1073 LIVERPOOL ROAD, MANCHESTER DESIGN AND ACCESS REPORT

TO PLANNING PERMISSION 117897/FO/2017

1073-TGA-XX-XX-RP-A-FI_10_10-00250

This report has been prepared by Tim Groom Architects to describe proposed non-material amendments to the Planning Application Number 117897/FO/2017 and support the Listed Building Consent Application for the revised scheme.

5.0 BASEMENT FLOOR PLAN

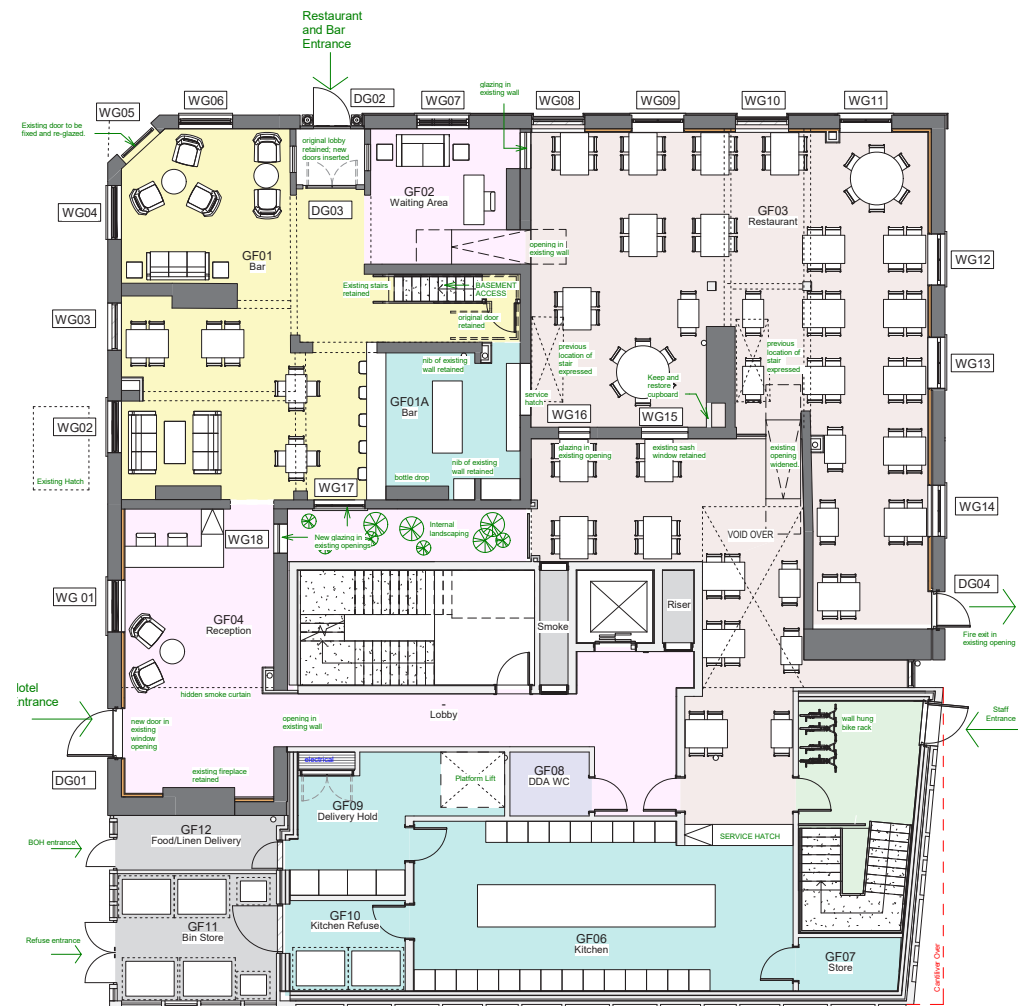
- 1. Spa area and changing facilities introduced to new-build basement to achieve 5* rated hotel amenities.
- 2. WC facilities and spa treatment rooms added to no.123 basement to achieve 5* rated hotel amenities.

5.1 GROUND FLOOR PLAN

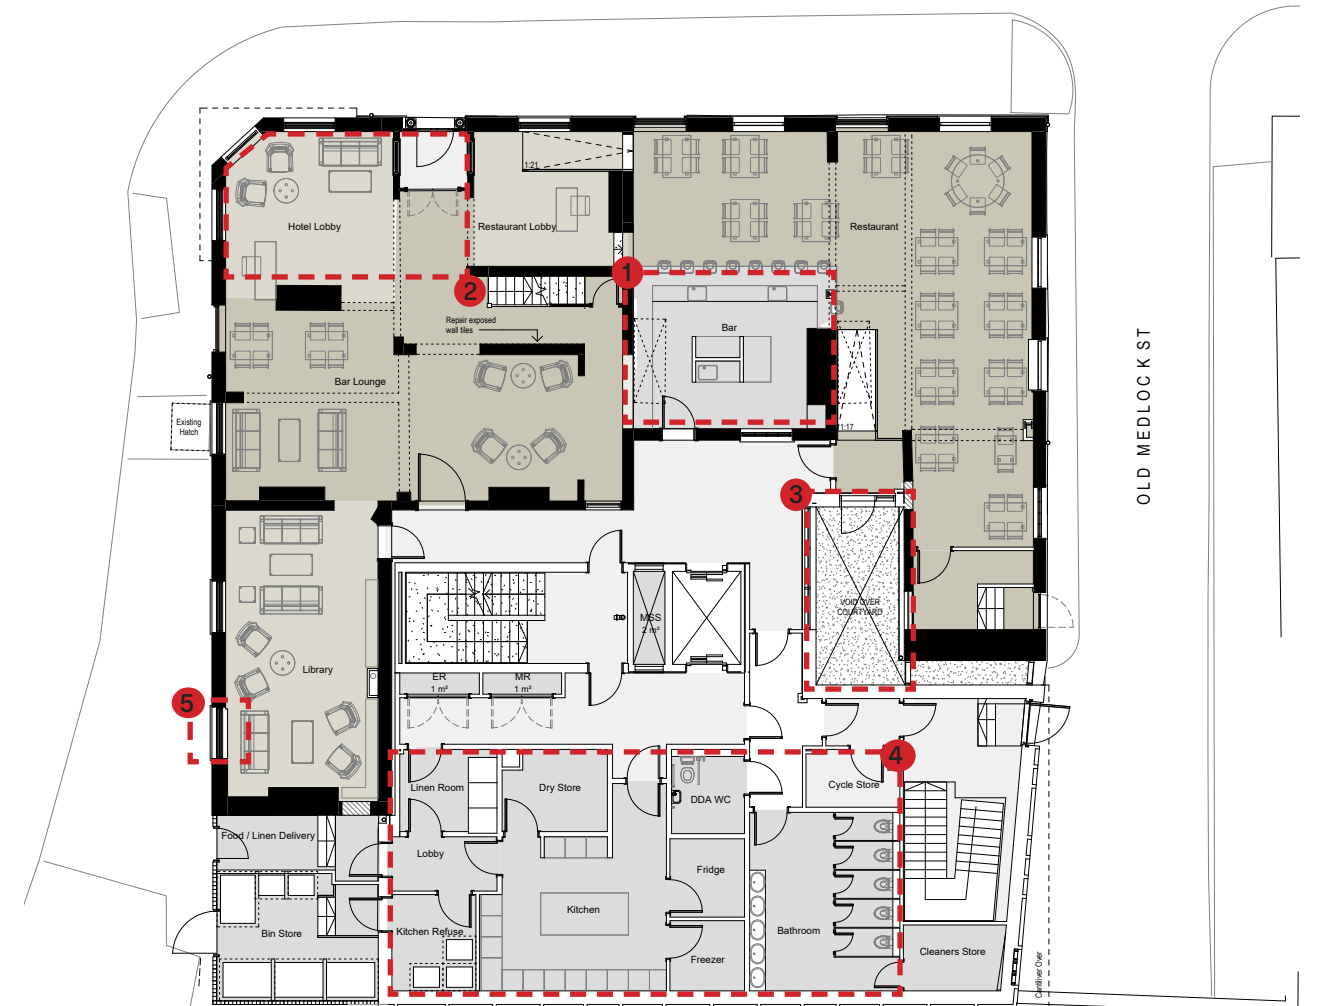
1. Placement and general arrangement of bar area amended to serve bar & restaurant and create larger bar seating area.
2. Hotel entrance location changed and waiting area amended to retain importance of original building entrance.
3. Inclusion of internal courtyard with access from the restaurant to bring light and a focal point into the centre of the plan.
4. General arrangement changes of kitchen, WC's and service spaces for improved circulation.
5. Proposed previous hotel entrance omitted and existing window retained.

5.2 FIRST FLOOR PLAN

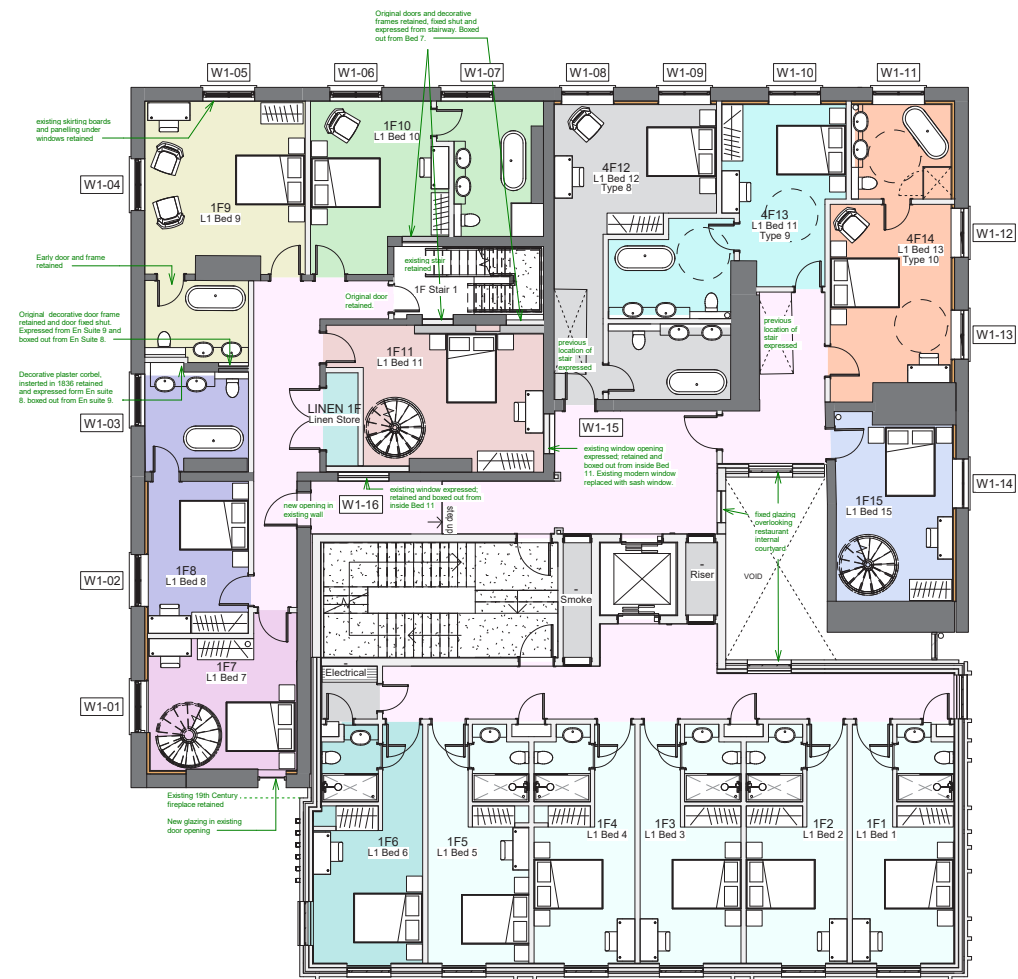
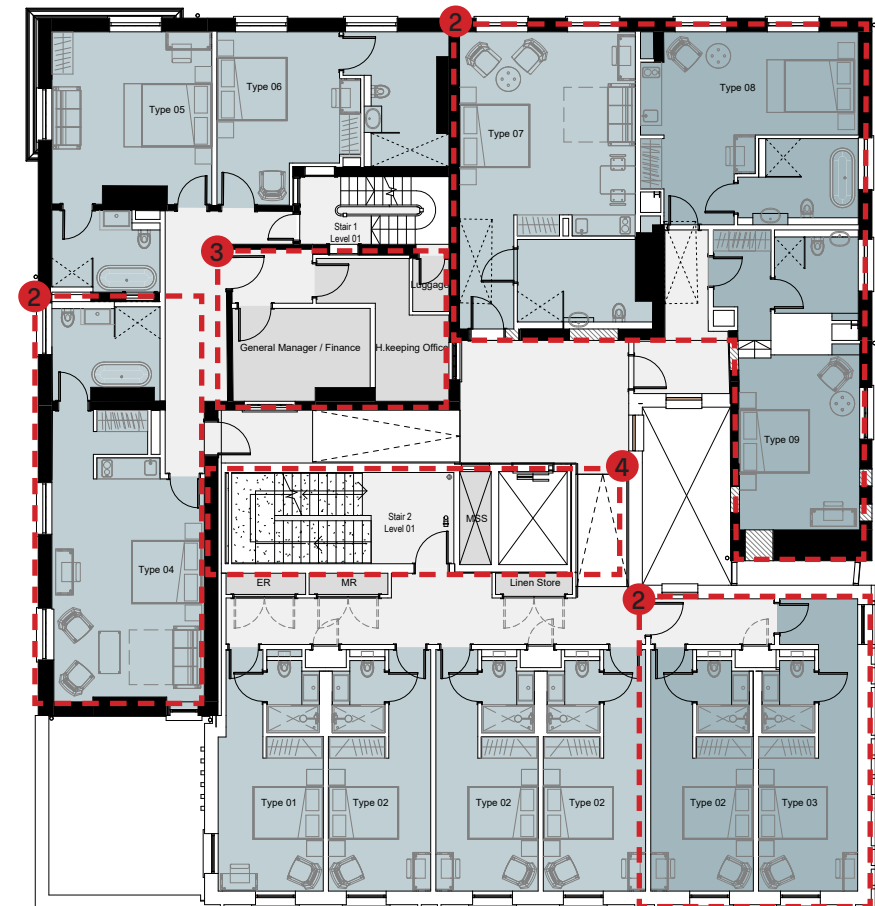
1. Removal of duplex hotel rooms for improved room layouts and a wider appeal through diverse room features such as kitchenettes, lounge areas, lock off rooms etc. This design also improves on the legibility of the historic plan form.
2. General amendments to room layouts of existing building resulting in larger room types that are more sympathetic to the buildings historic use.
3. Inclusion of staff BoH areas to provide additional offices.
4. Alterations to main circulation core for improved circulation.

5.3 SECOND FLOOR PLAN

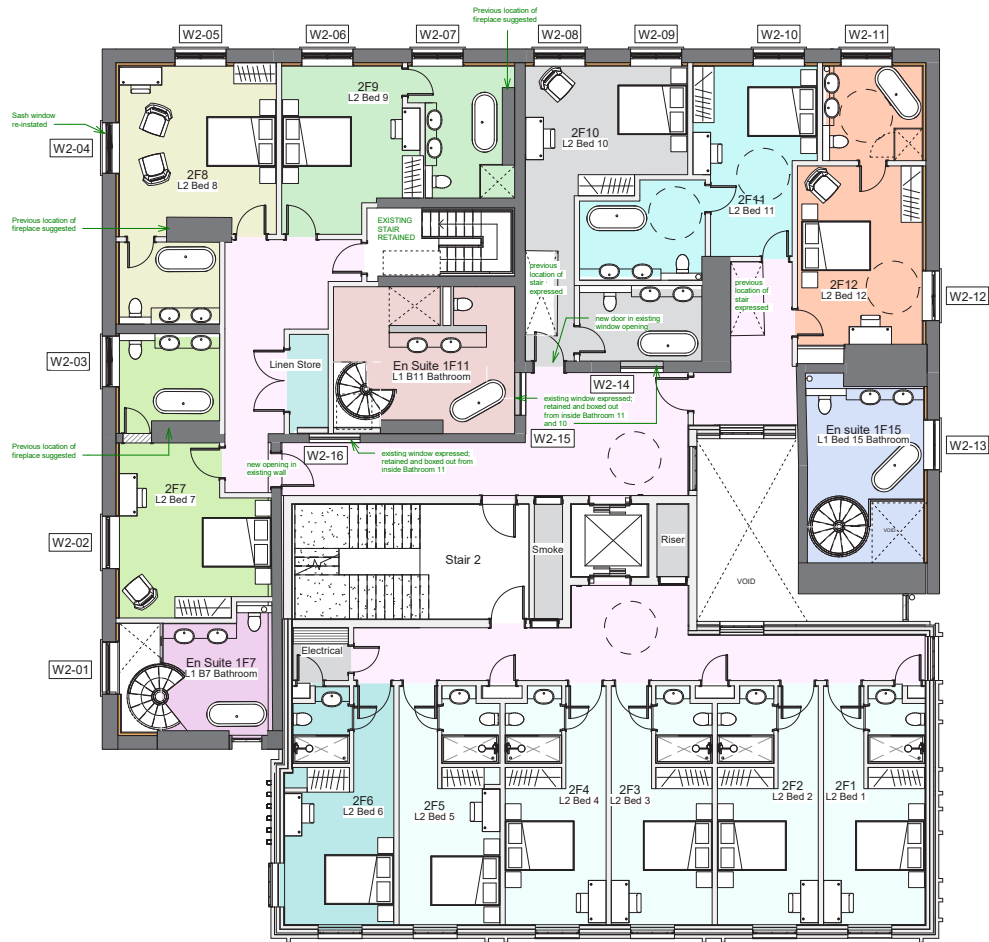
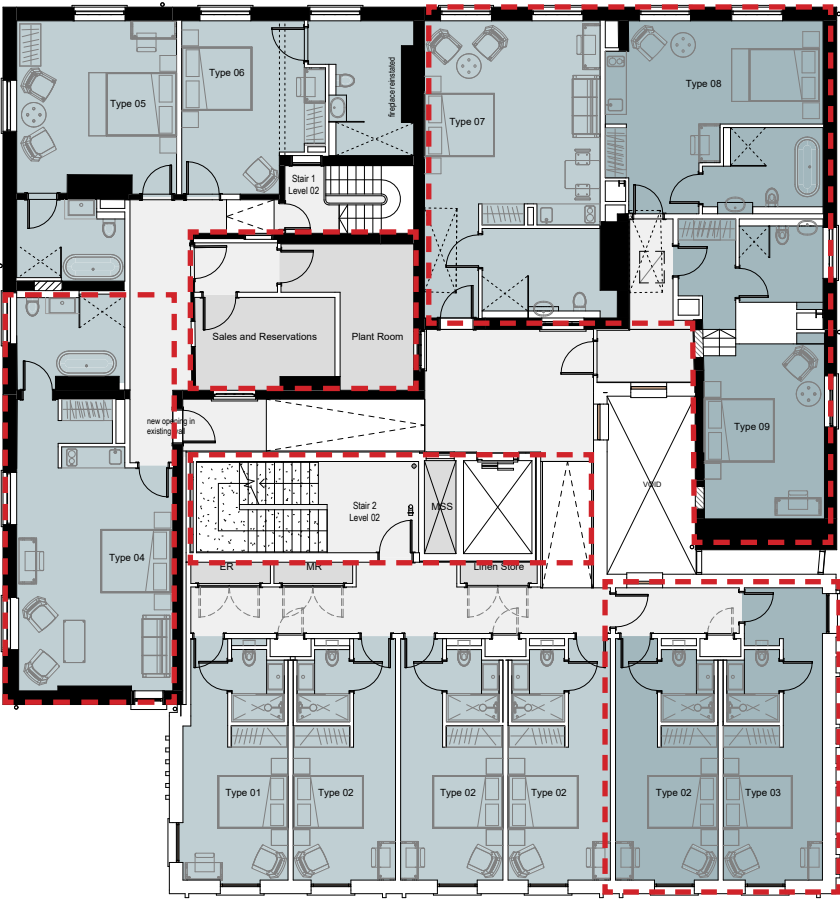
As level one plan.

5.4 THIRD FLOOR PLAN

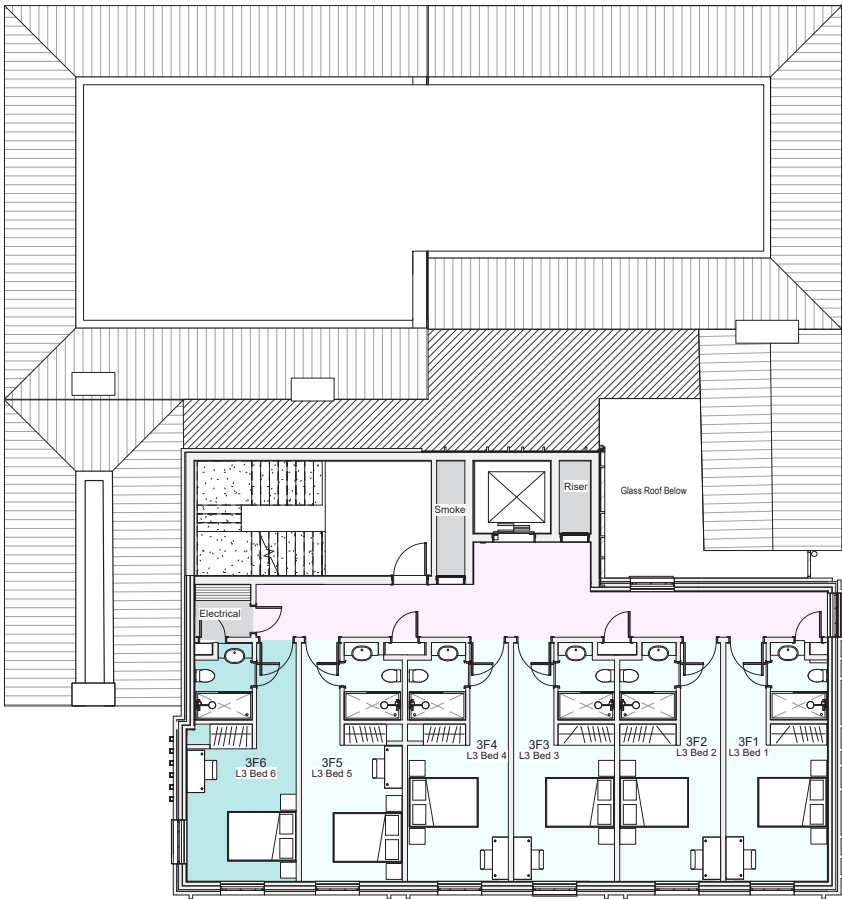
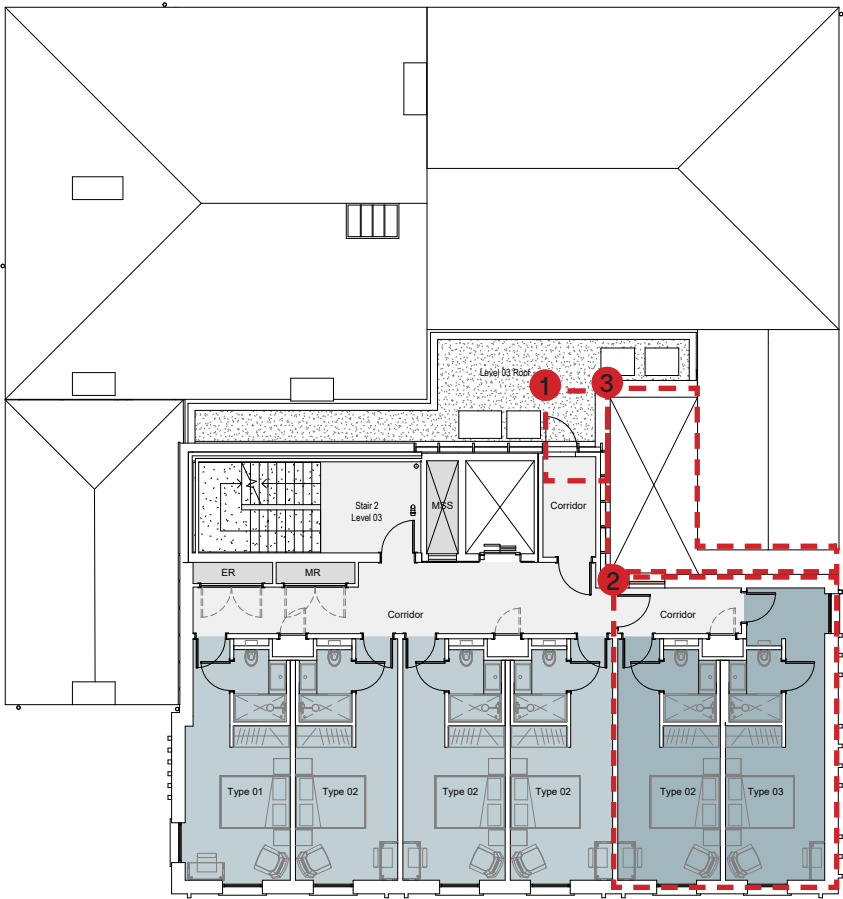
- 1. Additional roof access provided for maintenance and discrete locating of plant.
- 2. Minor alterations to internal layout that include lock-off rooms to expand hotel offering.
- 3. Glass roof omitted to remove maintenance risk.

5.5 FOURTH FLOOR PLAN

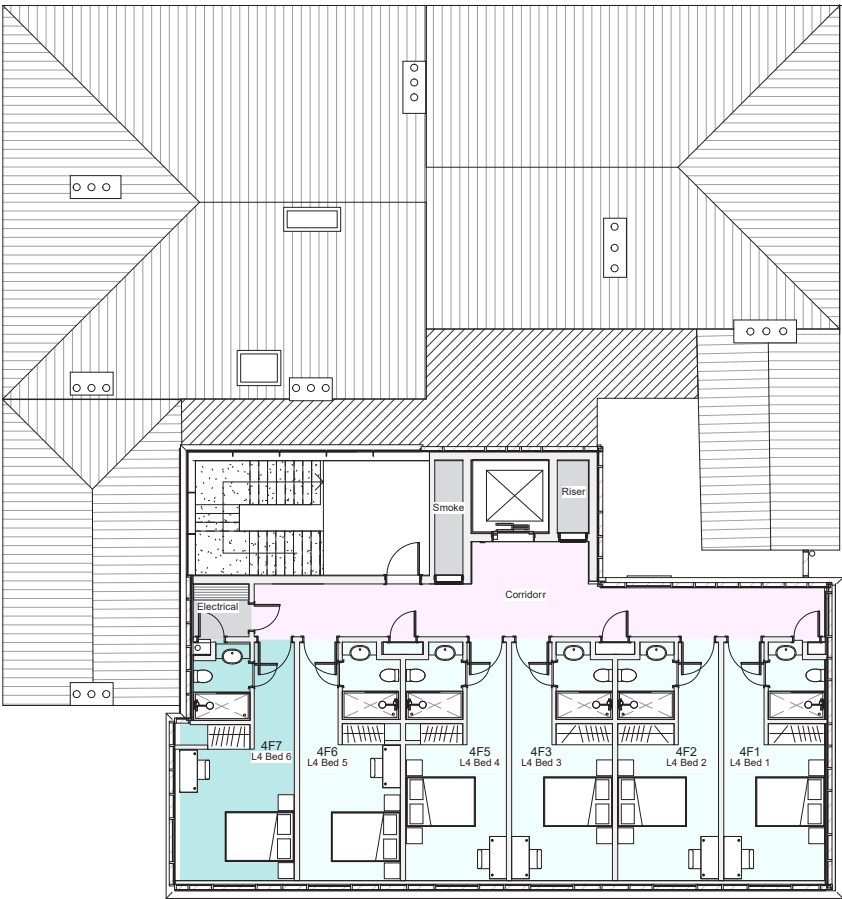
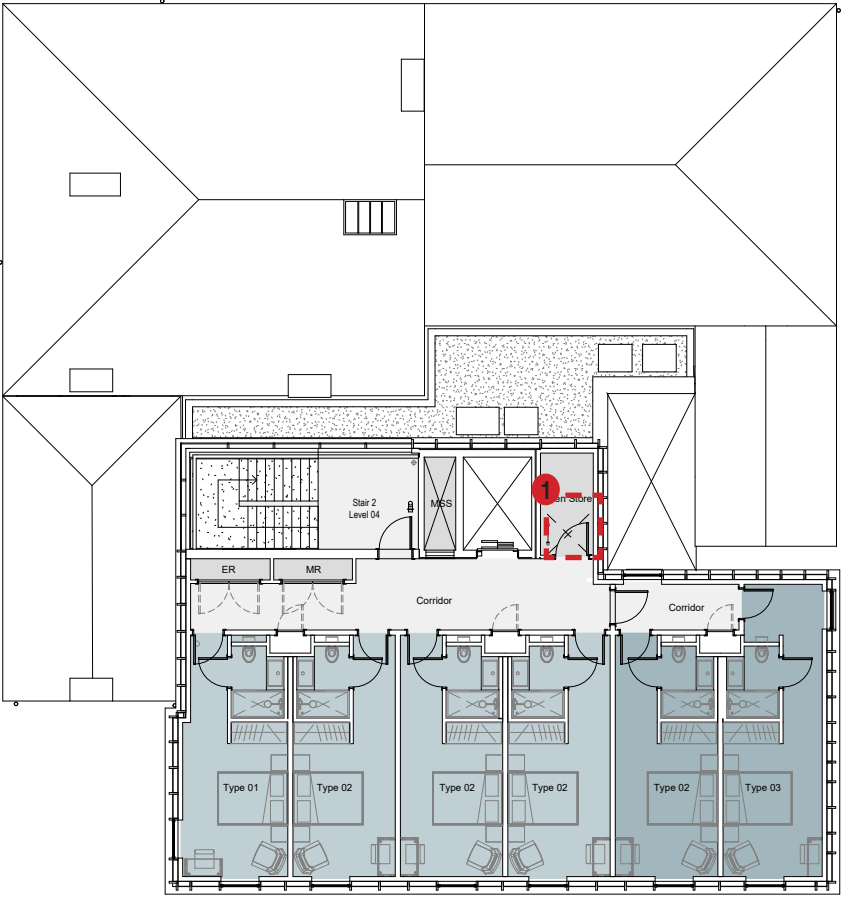
- 1. Roof access hatch with ladder amended to inside linen store for private access for maintenance.

5.6 ROOF PLAN

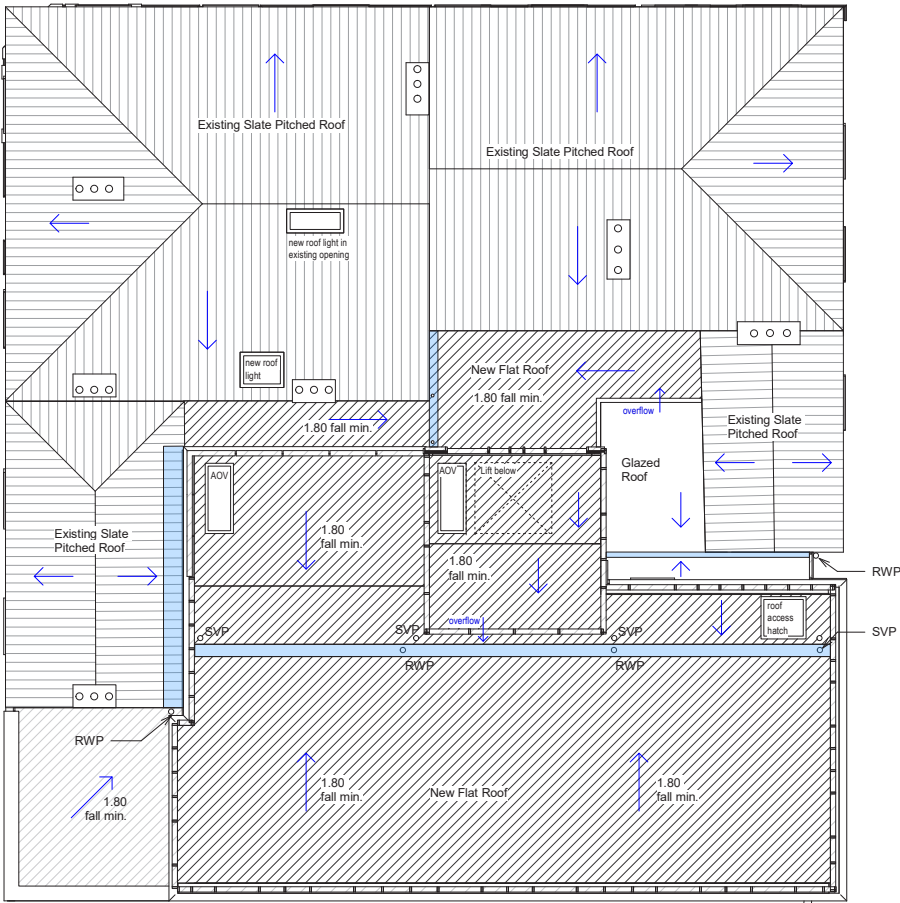
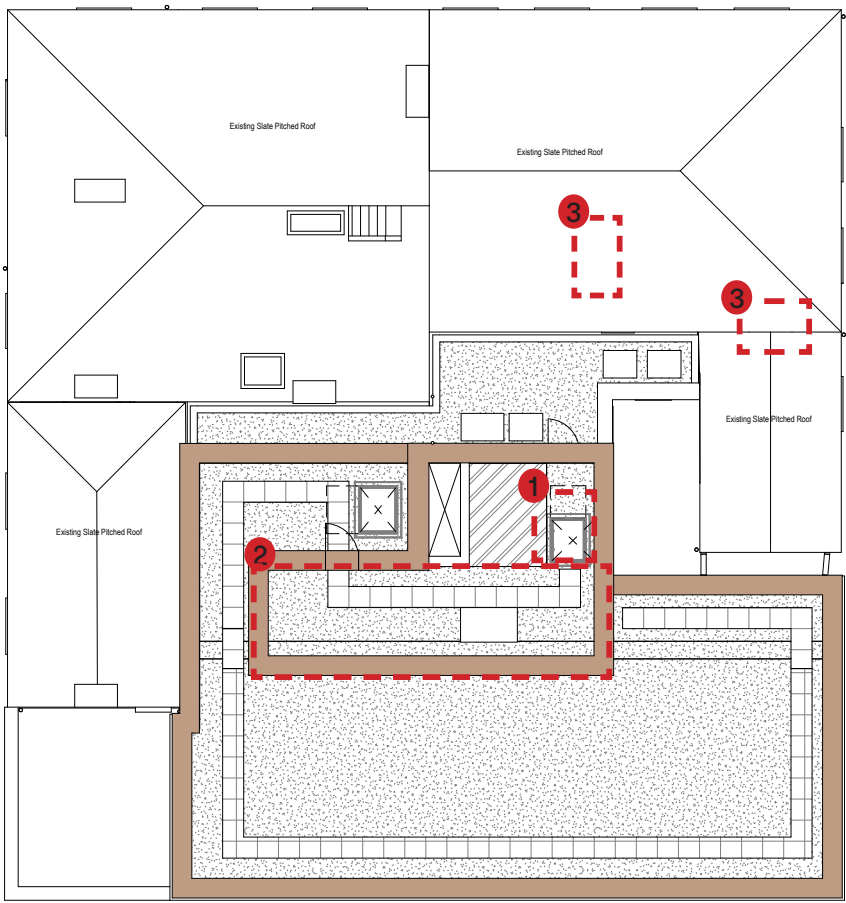
- 1. Amendment to location of roof access hatch.
- 2. Plant screening extended due to increased plant demand to meet current regulation requirements for the building operation.
- 3. Proposed chimneys in previous application omitted.
